Colorado Interstate
Gas Company, L.L.C.
a Kinder Morgan company

Re: Colorado Interstate Gas Company, L.L.C.;
Docket No. CP19-56-000;
Supplemental Environmental Information

COLORADO INTERSTATE GAS COMPANY, L.L.C.
Response to OEP Data Request
Dated February 21, 2019 in Docket No. CP19-56-000
CIG High Plains Kiowa Lateral Expansion Project

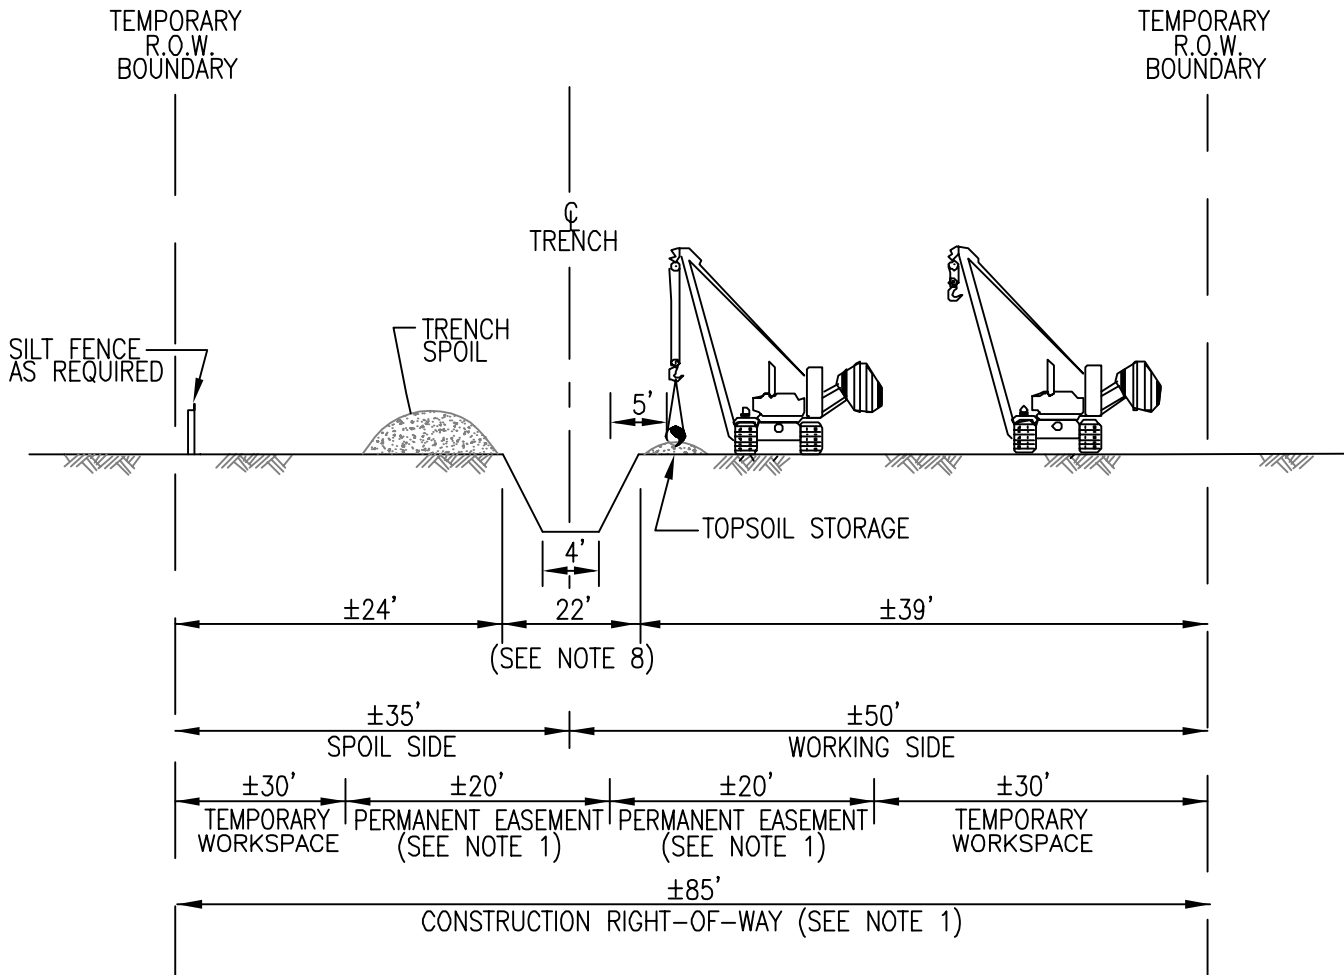
4. Provide construction methods and construction typical diagrams for side slope and “rough terrain” construction.

CIG has attached typical diagrams for side slope and “rough terrain” construction. Please see attachment 2 behind this response.
